## DEVELOPMENT REVIEW COMMITTEE MEETING NOTICE AND AGENDA

Notice is hereby given that the Santaquin City Development Review Committee will hold a regular meeting on **Tuesday September 8, 2020 at 10:00 A.M. at 275 W. Main Street**

2. Heelis Farms Final Subdivision Review

# HEELIS FARM TOWNHOMES

\2019\19-079 Heelis Farms Townhomes\CADD\PRFLIMINARY\01-COVFRSHFFT.dwa 9/1/2020 10:37:34 AM MDT

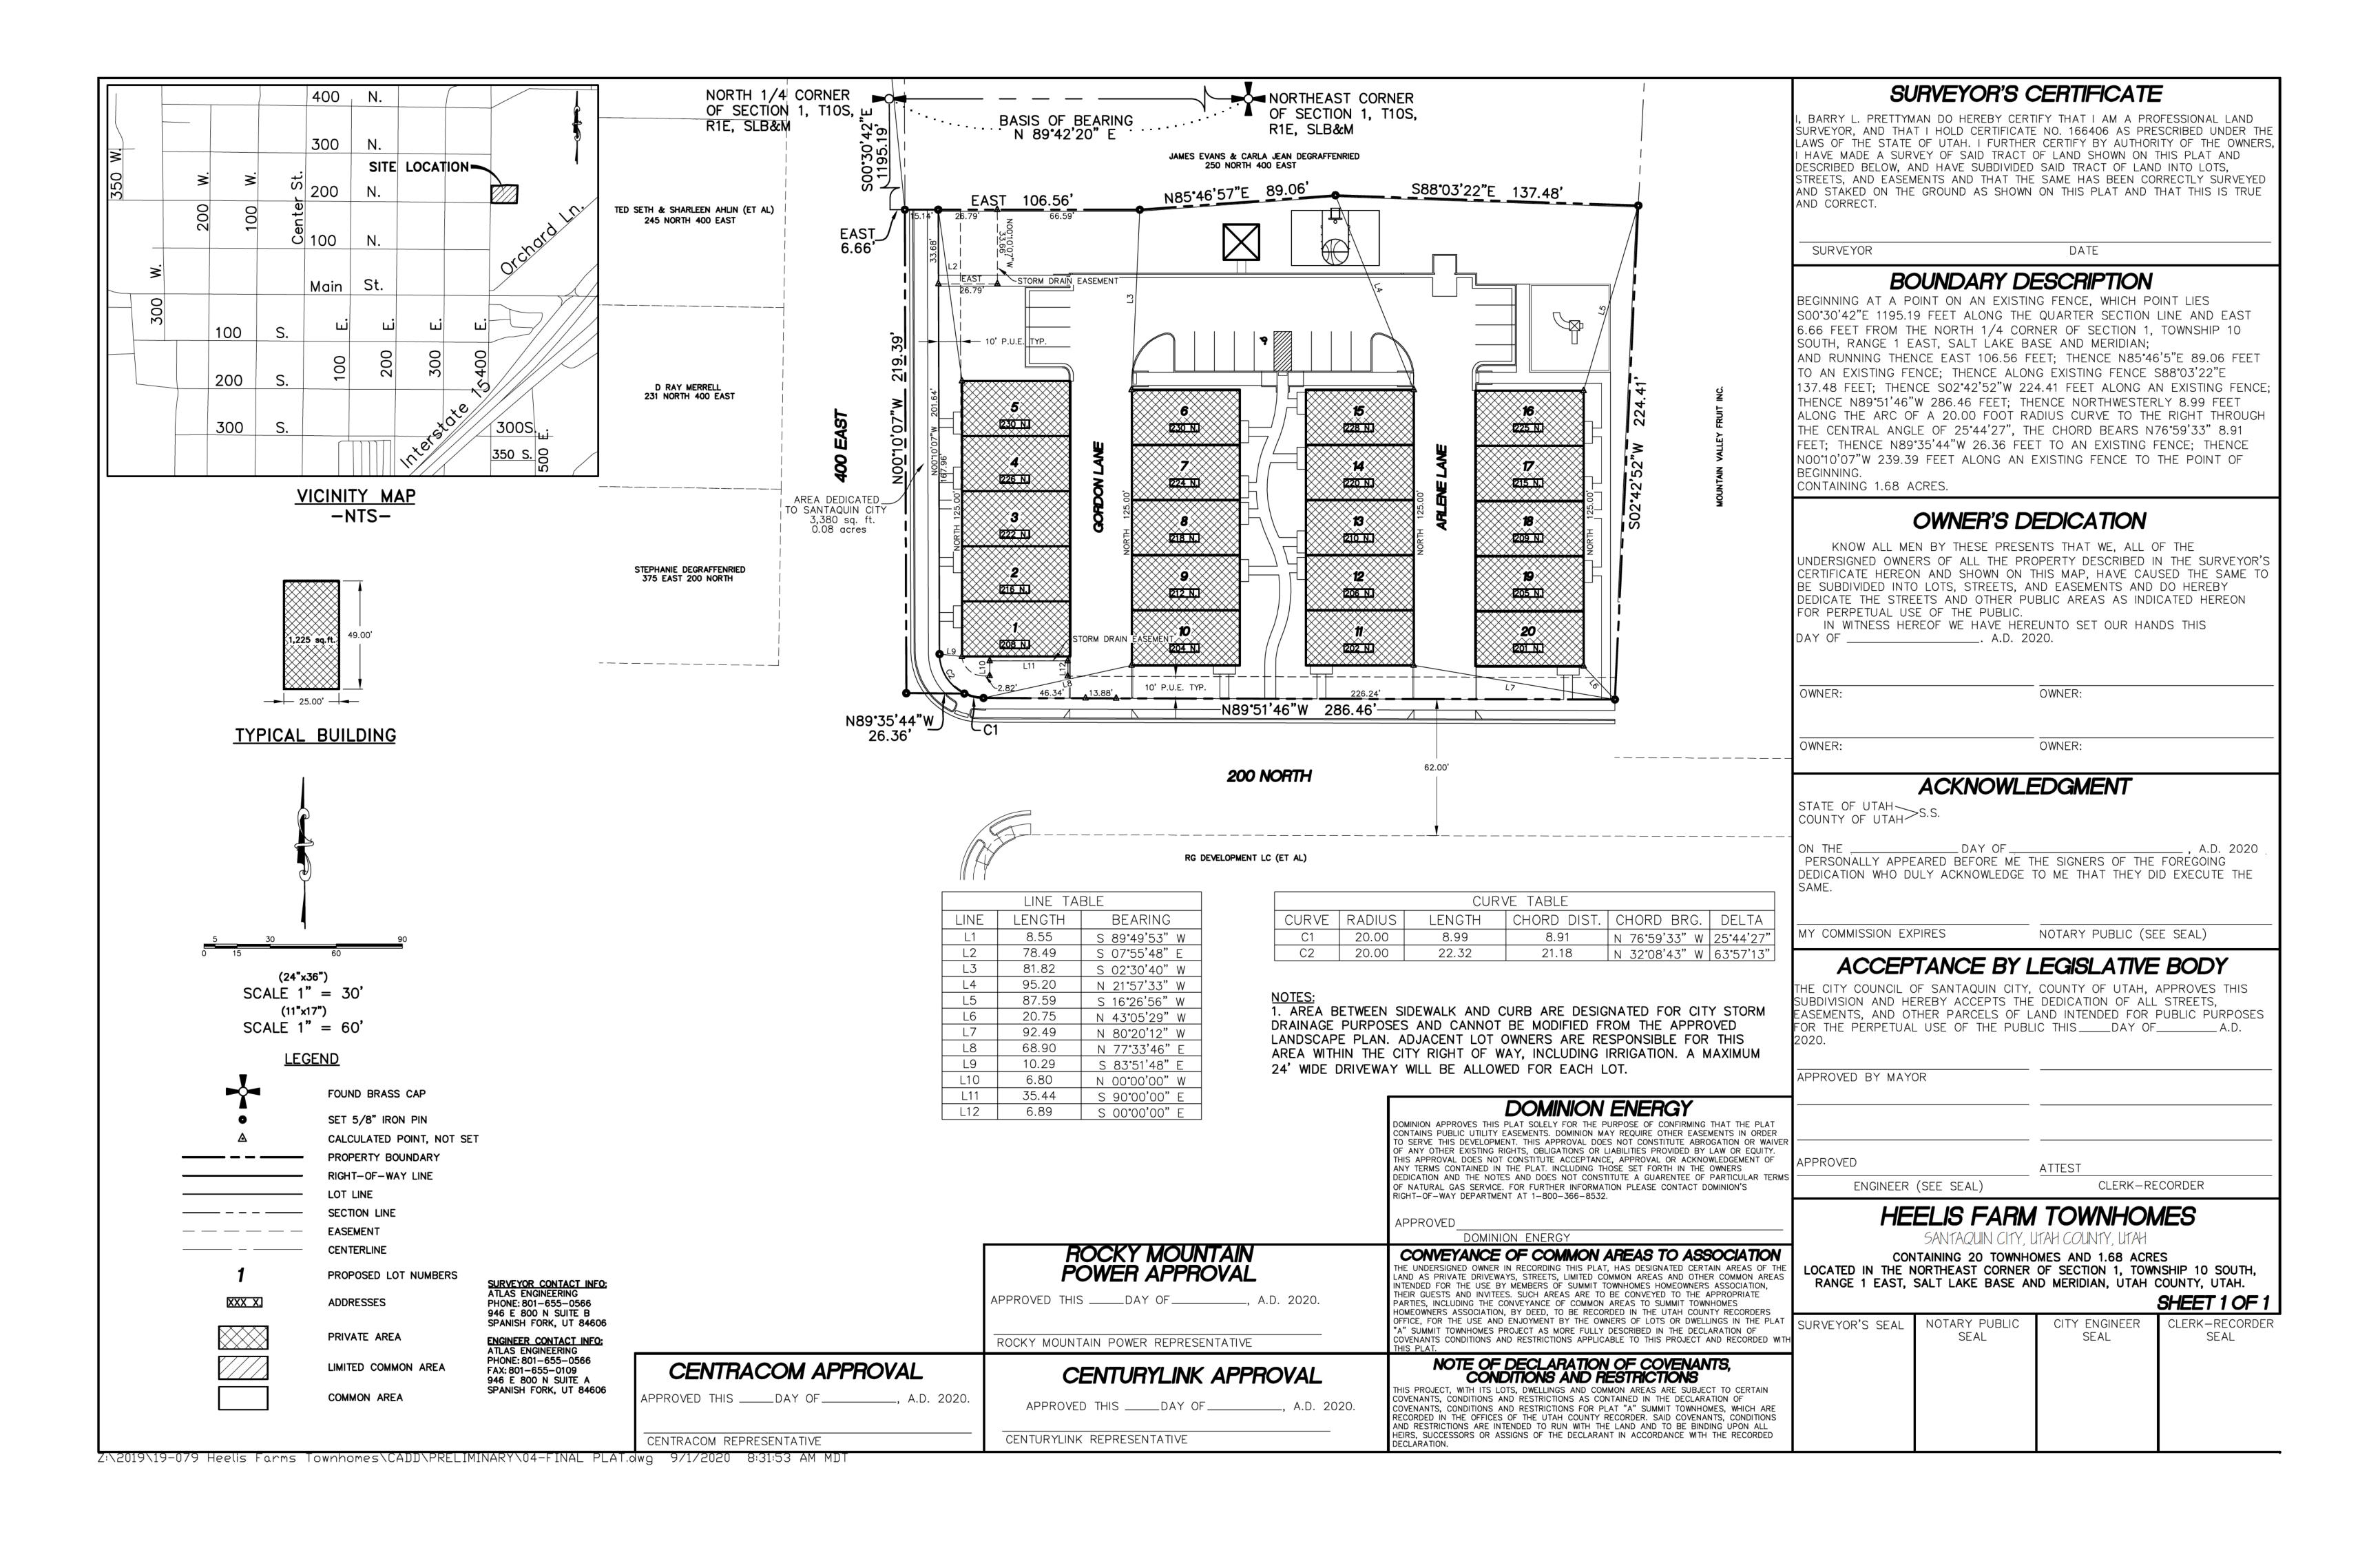
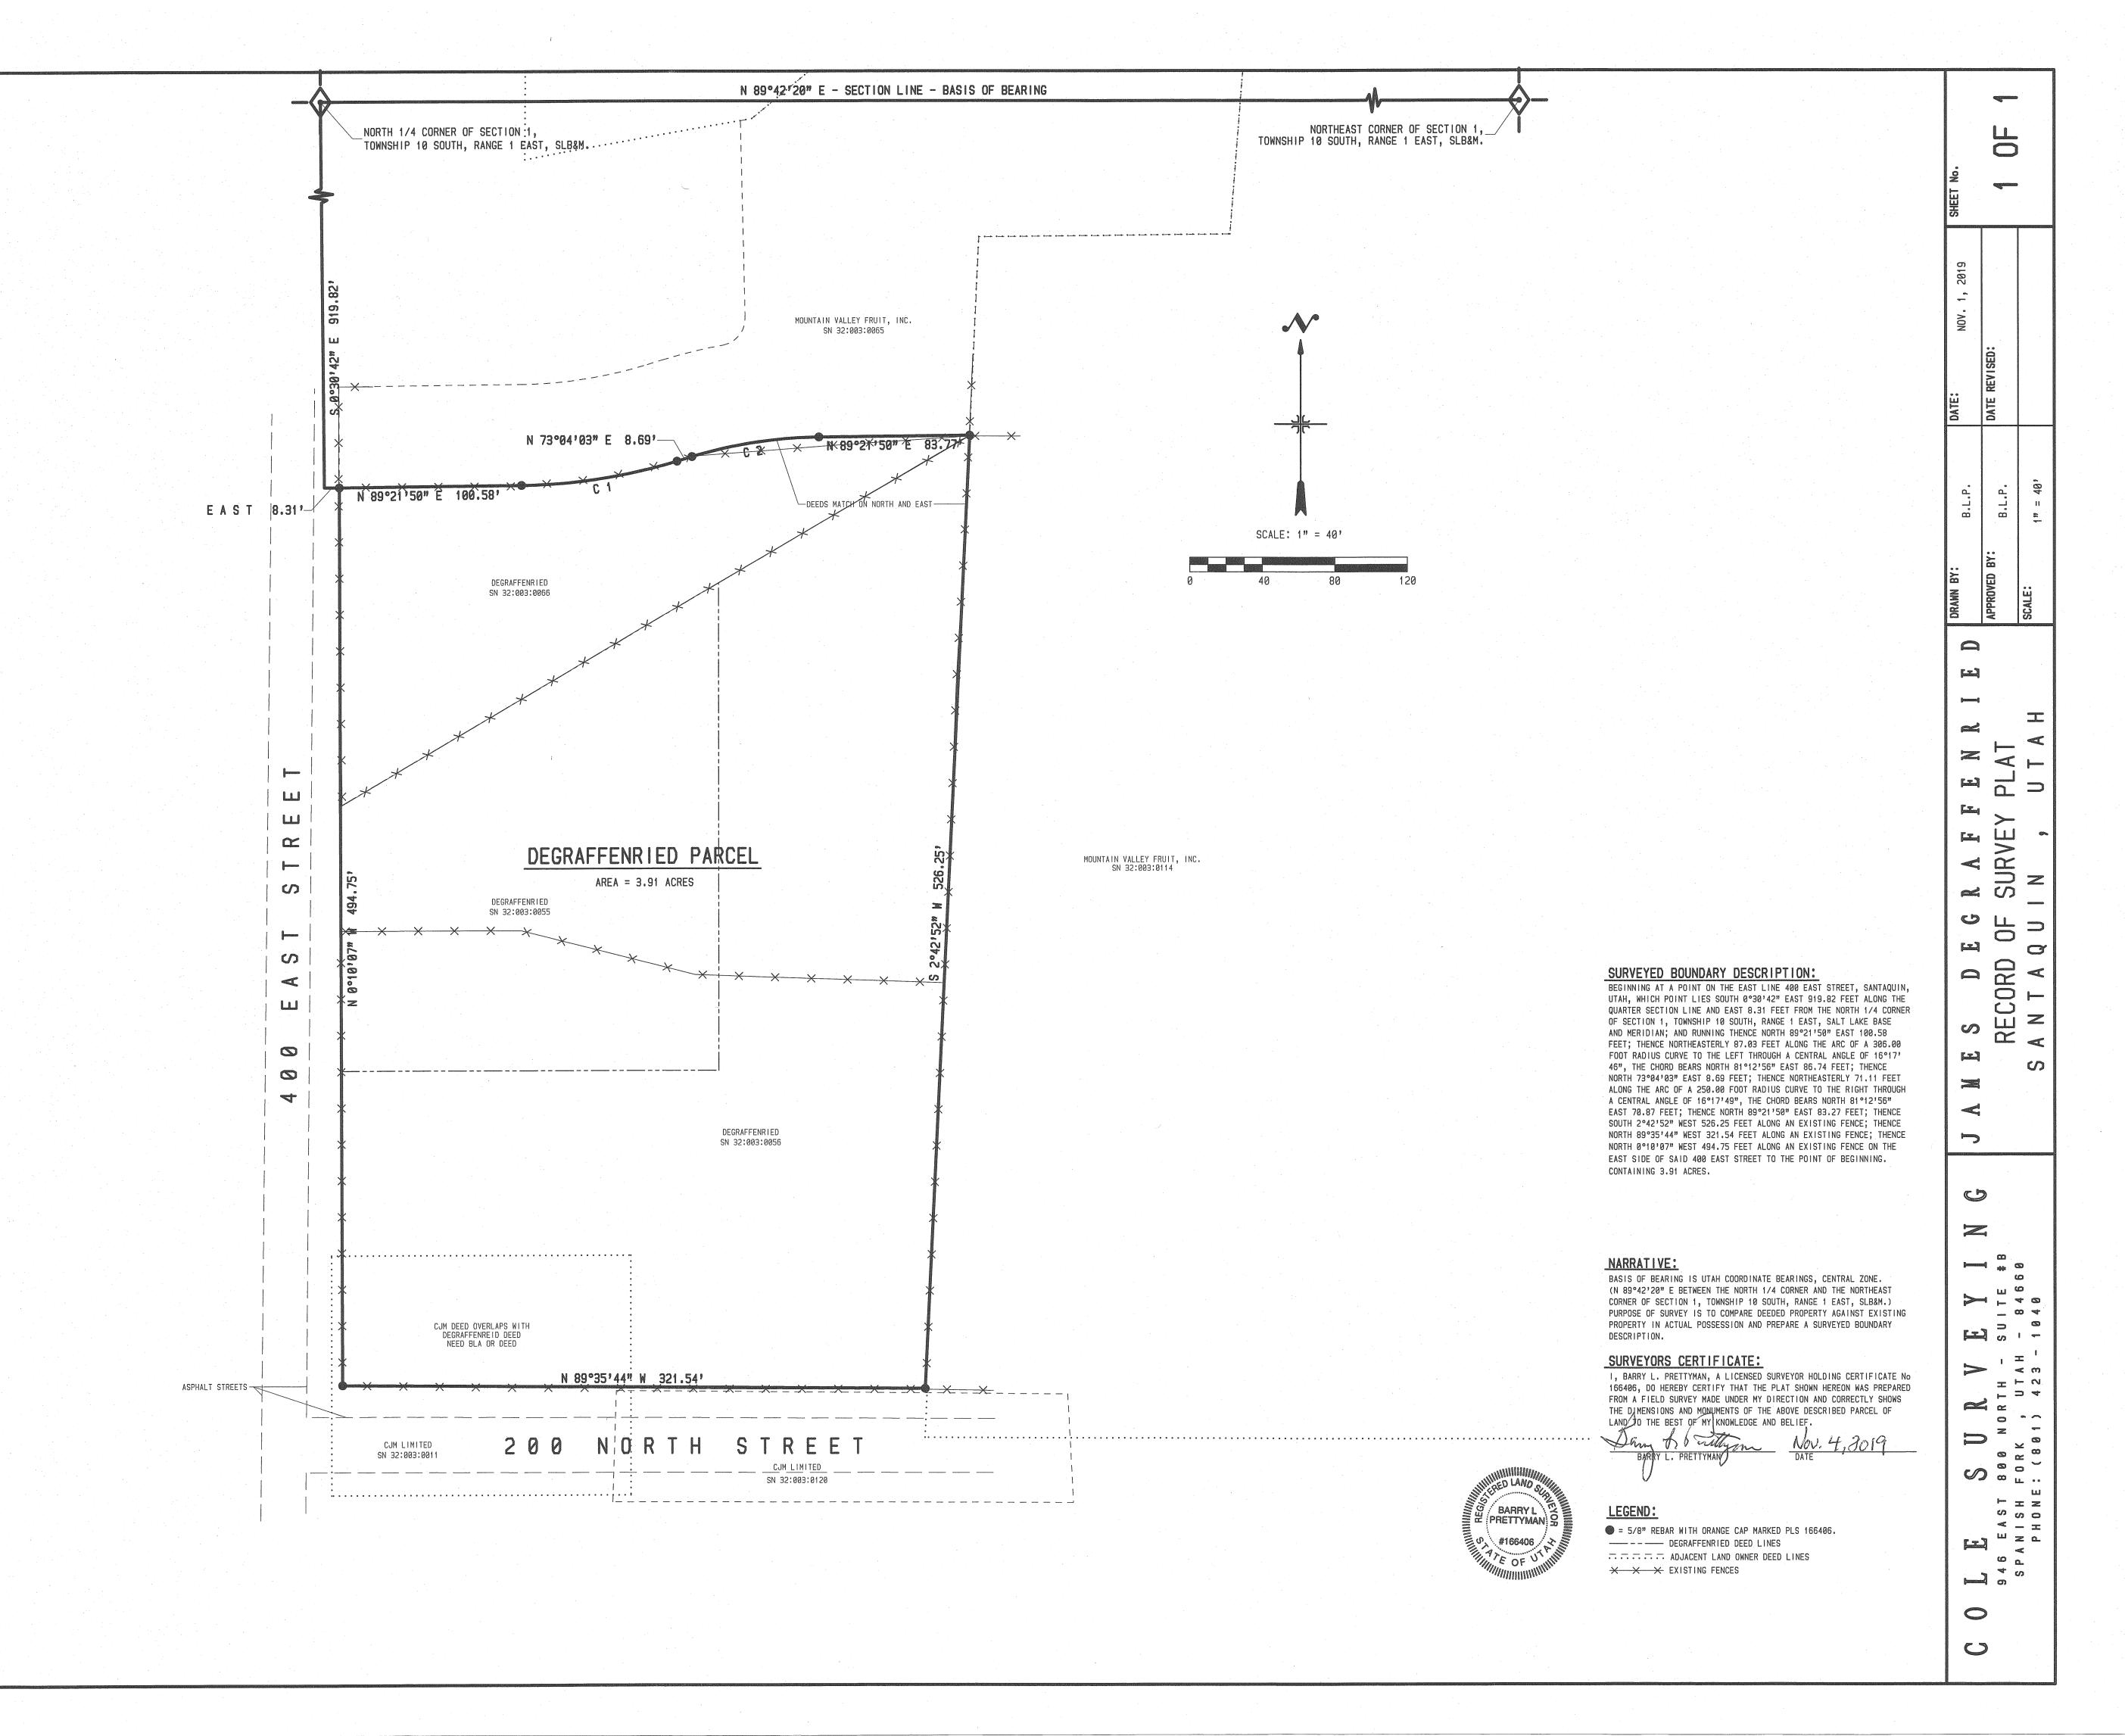
**Public Works:** Mr. Eva asked how many water meters the development will have? Mr. Lundell stated that the plans indicate that there will be two, four inch meters feeding 10 units each. Mr. Beagley explained to the developer that if both meters are proposed to be located in one vault, the vault will need to be sized appropriately for work access. Mr. Eva suggested that 4 two inch

**Police:** Chief Hurst verified that 400 East will be red curbed. He also reiterated that the trees need to be placed away from the driveway areas. Mr. Beagley explained that 400 E. will be red curbed and it will wrap around the corner of 200 N. to the first driveway of the development.

**Building Official:** Mr. Spadafora verified that the proposed addresses are off of Heelis Loop and look ok. He asked public safety to verify that the addressing works for them. Mr. Bond noted that units 10, 11 and 20 face 200 N. and suggested that they be addressed off of 200 N. instead. Mr. Reeves suggested that the roads are named East and West Heelis Loop to avoid confusion. Mr. Beagley suggested that the private access have two separate names, as there is nothing addressed off of the back of the loop. The DRC directed the developer to provide two different street names.

Engineering: Mr. Lundell stated that the CC&R's are still pending. He noted that the parking requirement is being met, but the numbers on the plans don't correlate with what is shown. He also communicated that the plan and profile for the sewer line on 200 N. is missing. Mr. Lundell indicated that there is an existing high pressure gas line that runs along the north side of 200 N. The label for the gas line must be updated to show that extreme caution be used while working around the pipe line. Mr. Lundell explained that based upon the record of survey, the south property line of the project extends straight west and doesn't follow a curve. He indicated that if the area is to be dedicated to the City, it needs to be called out and shown on the plat. He asked that the names for the private accesses aren't coordinate addresses to avoid confusion with public streets.

Mr. Greenhalgh asked why the sewer can't be installed off of the North side of the property in order to avoid tearing up the new road and the high pressure gas line. Mr. Beagley stated that the Engineering redlines are based off of the plans that have been provided. Different options for the sewer line were discussed. Mr. Lundell indicated that another proposal for the sewer line can be submitted and reviewed.

**Motion:** Mr. Bond motioned to table the Heelis Farms Final Subdivision Review so the missing plan and profile can be submitted and the sewer line location can be discussed and possibly reconfigured. Mr. Spadafora seconded. The vote was unanimous in the affirmative.
